5. ASSESSMENT

The Department considers the key environmental issues for the project to be:

Figure 6: Draft LEP height controls for the site (source: Draft North Sydney LEP 2009).

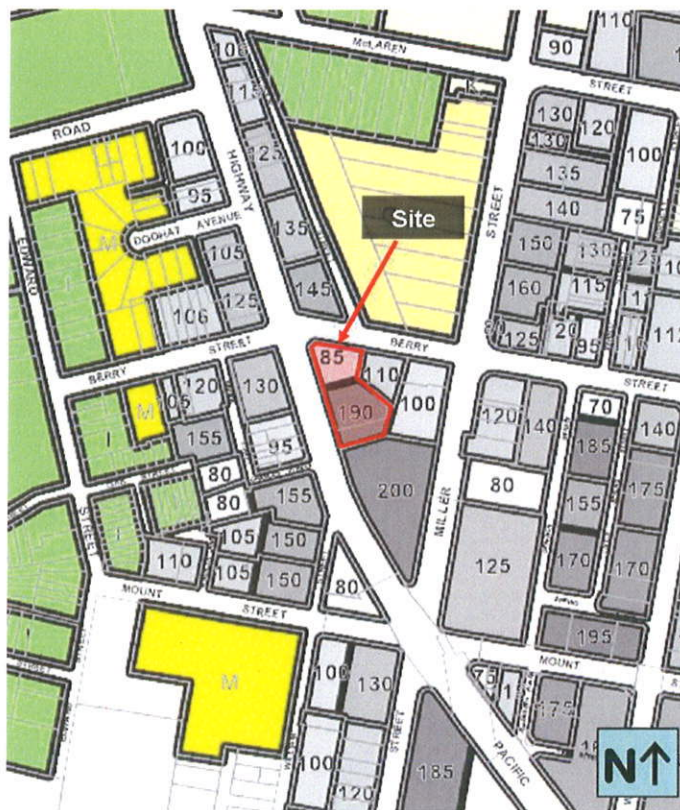
The draft North Sydney LEP 2009 would reduce the height control for the site by part 5 metres over part (southern portion) of the site and 110 metres over the remainder of the site (northern portion) to ensure that future building envelopes are well within the heights allowed by the Composite Shadow Diagrams and Special Area shadow controls (see **Figure 6**).

The proposed height complies with current numerical controls but not the draft LEP. The effect of the draft control is a significant reduction in the permissible building height for the site over the northern portion of the site at the corner of Berry Street and the Pacific Hwy (refer **Figure 6** above). This reduction will in turn have an impact on the allowable building envelope and floor plates able to be realised on the site.

Figure 8: Composite shadow diagram, which controls overshadowing outside the CBD. Note Special Areas are also shown (source: North Sydney LEP 2001).

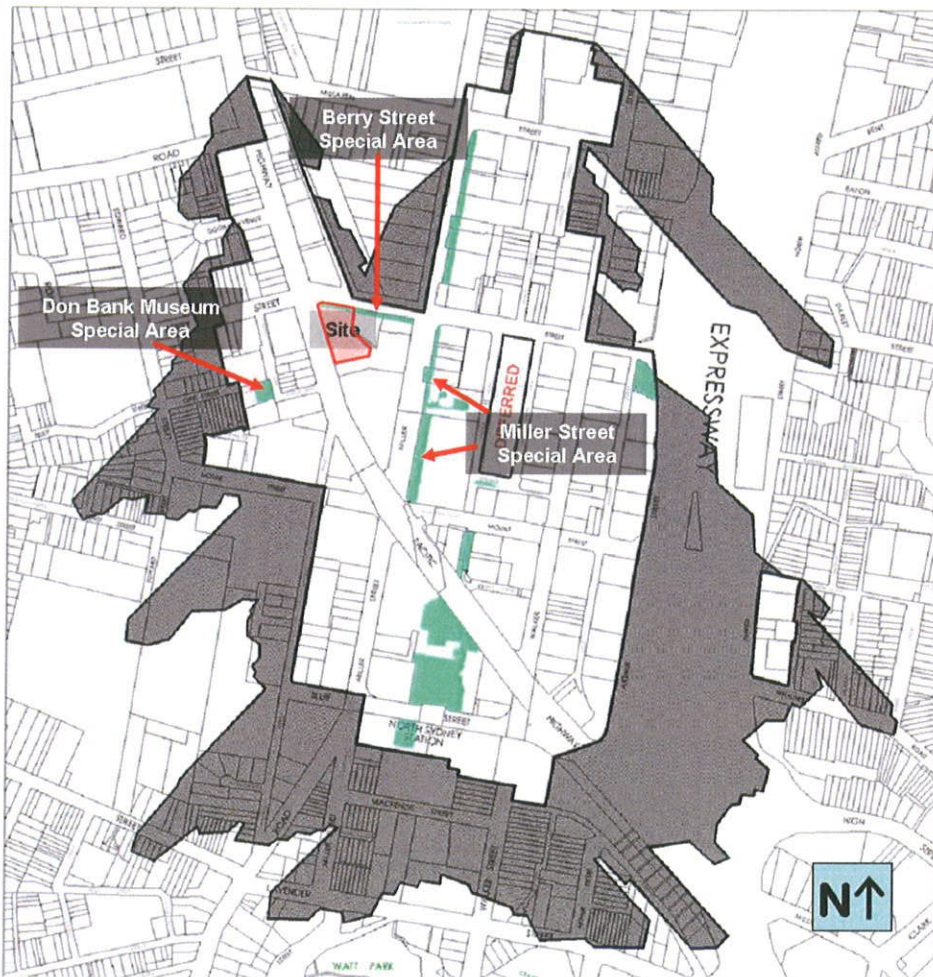
Both LEP 2001 and the Draft LEP 2009 contain a height/envelope shadow control which prescribes that there should be no net increase in overshadowing to land outside the CBD between 9:00am and 3:00pm year-round beyond the footprint of the "Composite Shadow Diagram" (see **Figure 8**).

The proposed building envelope will result in some additional shadowing to land outside the Composite Shadow Area at the winter solstice. The overshadowing would affect properties to the west of the CBD between 9.00am and 10.00am. These areas are not considered sensitive land or areas of principal open space, but rather the intersection of Lord and Edward Streets, driveways, car parking and landscaped areas and a building within the Shore School (see **Figure 7**).

Figure 13: Aerial photograph of the Museum and surrounding buildings – height in storeys shown (source: NSW LPMA).

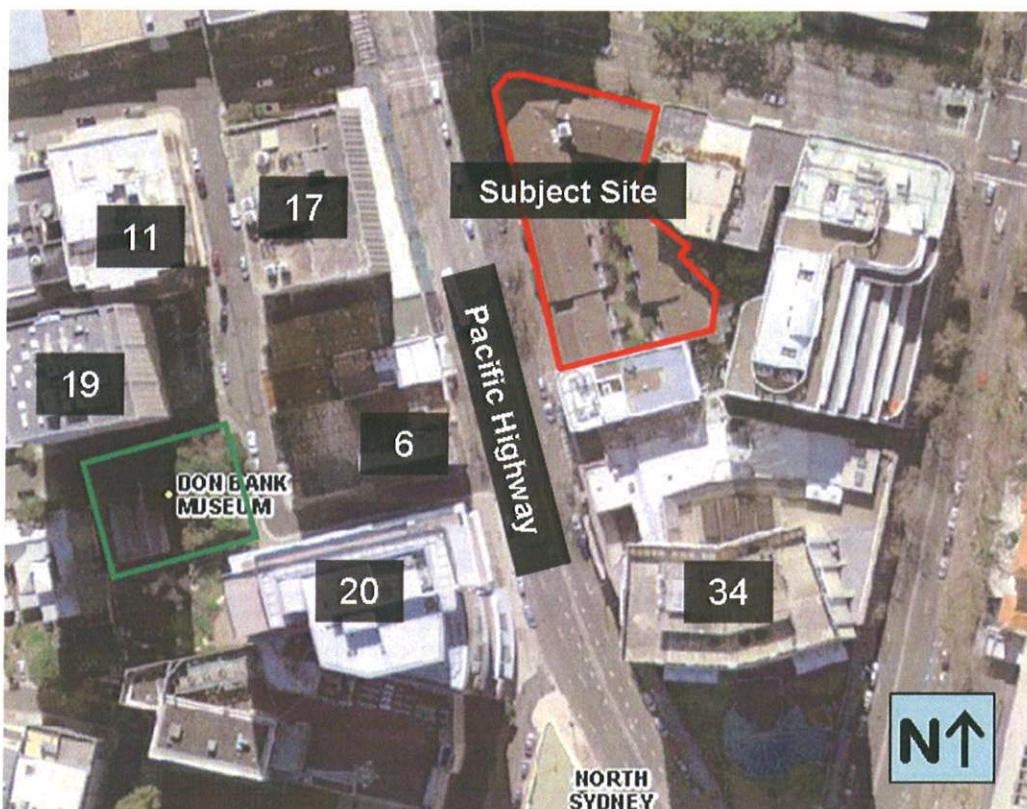
The Don Bank Museum is located a block west of the subject site on Napier Street on an isolated site surrounded by much larger buildings (as seen in **Figure 13**). The Museum is owned and operated by North Sydney Council and is accommodated within an early 19th century timber slab cottage which is listed on the State Heritage Register. The Museum has a landscaped forecourt with limited seating, accessible between 7:00am-7:00pm daily.

Some areas affected by shadows within the Museum site do not require solar access to function effectively, such as within the Museum building itself, which makes up a significant portion of the site. Adjacent buildings cast most of the shadow onto the site on an 'average' day, primarily from the 19 storey commercial building which sits hard against the northern boundary of the museum site. The overshadowing impacts on the Don Bank Special Area are isolated to the earlier part of the critical 10am – 2pm range.

Figure 14: West elevation proposed in EA (left), with PPR revision on right (source: PPR).

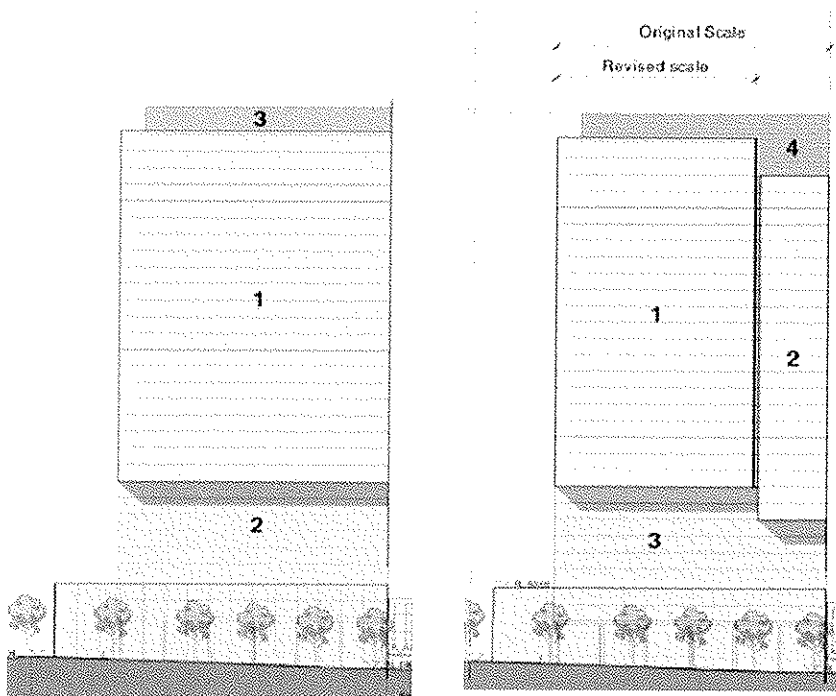
The Department requested that the Proponent address the bulk of the proposed building, particularly as viewed from the west. Compared to the north and south elevations, which read as a slender, asymmetrical tower above a lightweight podium, and the eastern façade, which provides visual interest with cut-in sections, the western elevation proposed in the EA presented an uninterrupted, monolithic façade which reduced the urban design quality achieved in other building elevations.

The PPR has revised the articulation of the western façade of the building by introducing a 'slipped' element to the southern side of the elevation (**Figure 14**). The massing and detail of the western elevation will effectively break up the visual bulk of the building when viewed from the western periphery of the North Sydney centre. The revised articulation exhibits a greater degree of variation and visual interest, and reduces the apparent 'breadth' of the proposed western façade. The revised articulation satisfactorily addresses the Department's concerns at this stage of the development, and it is noted that the design will be able to be further refined in future detailed applications.
